Reviewers' comments are in black. Responses are in blue with changes to the text of the paper in blue italic. All line numbers in the responses refer to the revised version, not the original.

Responses to Reviewer 1

An uncrewed aerial system (UAS) that developed for observations of aerosol and cloud properties in the marine atmosphere was introduced in this study. Compared to the regular UAS designed for observation of vertical aerosol and cloud properties, the new UAS (Fixed Wing VTOL Rotator or FVR-55), reported to have the advantage of much longer endurance (~4 hours), much higher height ceiling (~3 km), with the ability of carrying heavier payloads (~6 kg). As the Payload equipped with commercialized instruments, the technological advances could be refer to the FVR-55 and its sampling system connected to the Payload, however, details of which was not provided clearly. In addition, the observation data was not well analyzed and weakened its credibility. Thus, before its publication, the following issues should be properly revised and improved.

Figure 2. Flow diagrams for a) Clear Sky and b) Cloudy Sky payloads.

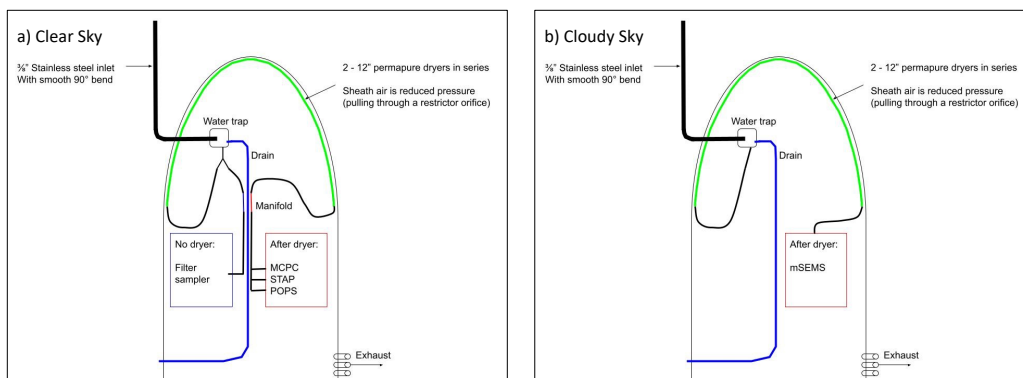
Line 97-101, It is unclear how the sample air passed through the nose cone of the FVR-55 then bring into the payload? Figure that showing the internal structure of the nose cone and the sample lines is needed here, which is important to evaluated the particle loss in the sample lines.

Line 159-162, is the multi-channel filter sampler share the same sampling line with the other instruments? If so it would compete the air mass with the MCPC and POPS which has much lower flow rate. Please explain it.

We have added more information about the plumbing inside the payloads as well as a flow diagram to Section 2.2.1. as follows (lines 104 – 134):

“An isokinetic inlet is mounted on the nose cone of the FVR-55 to bring sample air into the payload under vacuum (See Figure 2). No changes in particle number concentration coinciding with the UAS transitioning from large spirals (1 to 2 km) to level leg flights were observed, indicating the performance of the isokinetic inlet was not impacted by a spiral flight pattern. Since particle number concentrations are dominated by the submicron size range this metric does not rule out effects in supermicron size ranges. In addition, the slow air speed of the UAS (25 m sec⁻¹) is expected to decrease impacts of the flight pattern on transmission of submicron particle through the inlet into the payload.

Sample air first encounters an inline water trap where water droplets are removed through impaction. The water trap has two outlets -- one outlet is for the sample line, which is under vacuum. The larger outlet exhausts condensate through a drain line that also allows excess ram air to passively exit the sampling system. Individual instruments sub-sample off of the sample inlet. For the Clear Sky payload, a perma pure drier is located downstream of the water trap and upstream of all instruments except the filter sampler (Figure 2a). For the Cloudy Sky payload, a perma pure drier is located downstream of the water trap and upstream of the mSEMS (Figure 2 b). A restricting orifice and filter on the inlet of the perma pure sheath air combined with a vacuum on the outlet of the sheath air was used to remove moisture from the sample stream. Instruments are cooled in flight by air flow through vent shafts cut into the nose cone frame.”

Also, Figure 2 was added to show flow diagrams for both payloads. See below.

The new flow diagrams in Figure 2 (see above) show the split in the sample air inlet between the chemical sampler and the real-time instruments indicating they did not share the same flow path.
